| | | Proposal from Japan |

JAPAN Proposal

ELECTRICAL SAFETY PROVISIONS FOR VEHICLES Post Crash

Figure 12: Measurement of V_b , V_1 , V_2

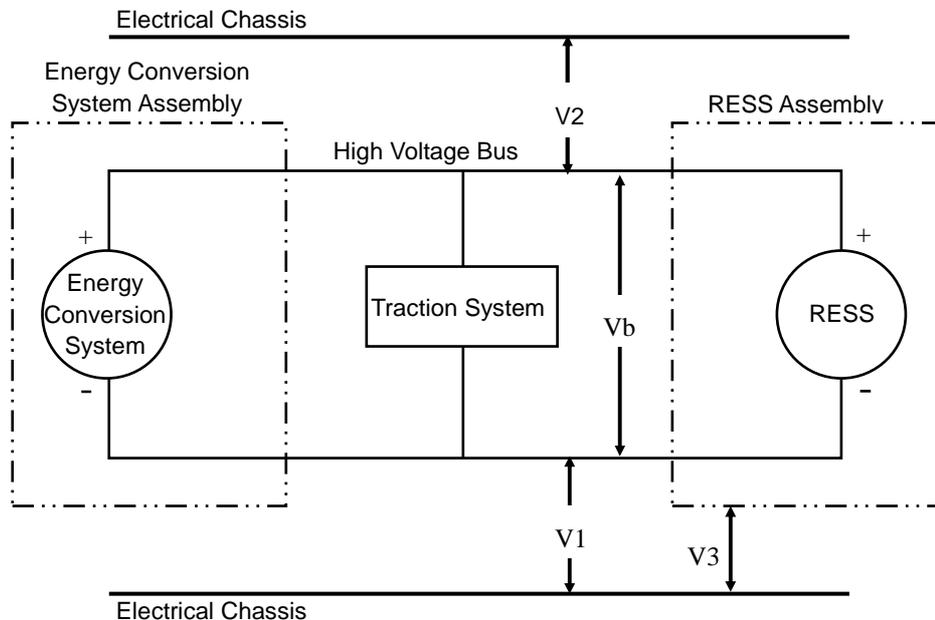
Comment: Even an OEM ensure that all exposed conductive parts are galvanically connected to the electrical chassis in pre-crash condition (this is the requirement of ECE R100), the certification body could not have confidence that this condition is maintained in post-crash. Therefore the measurement of V_3 is necessary.

"After 5 seconds" is tricky. OEMs must assume that the measurement is conducted just after 5 seconds by certified body.

The requirement of "5 seconds" comes from SAE J1772. It seems to be too conservative. Although I have no good alternative idea, I think it should be discussed in ELSA.

V_b is high voltage, conduct the specified vehicle crash test]. After the crash test, determine the high voltage bus voltages (V_b , V_1 , V_2) (see Figure 1). If the RESS has exposed conductive parts, measure the voltage V_3 between any exposed conductive parts of it and the electrical chassis. The measurement shall be made after [5 seconds of] the vehicle coming to rest after each crash test.

Note: Justification of "5 seconds" should be discussed again.

Figure 4: Measurement of high voltage bus energy

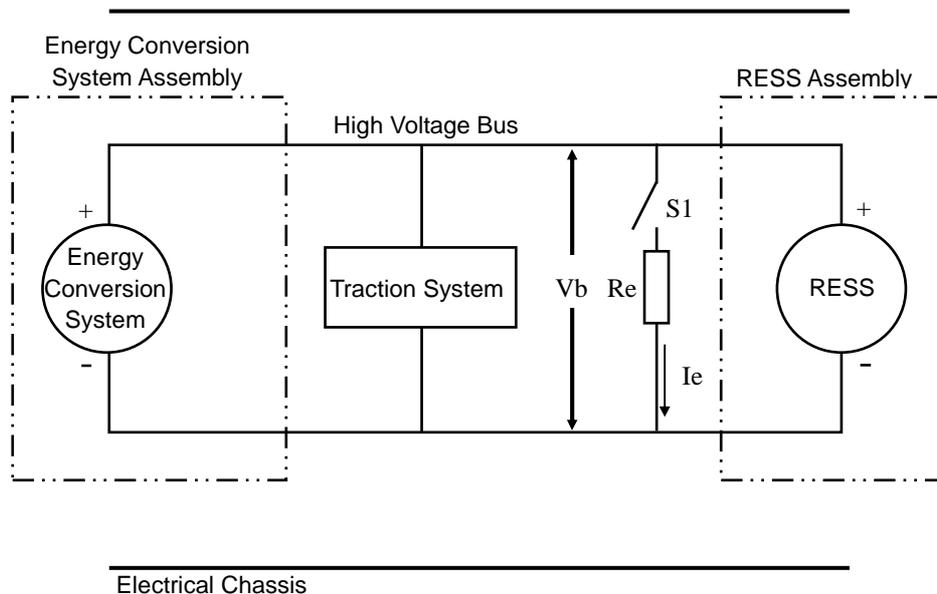
$t_0 = ???$
 $t_1 = ???$
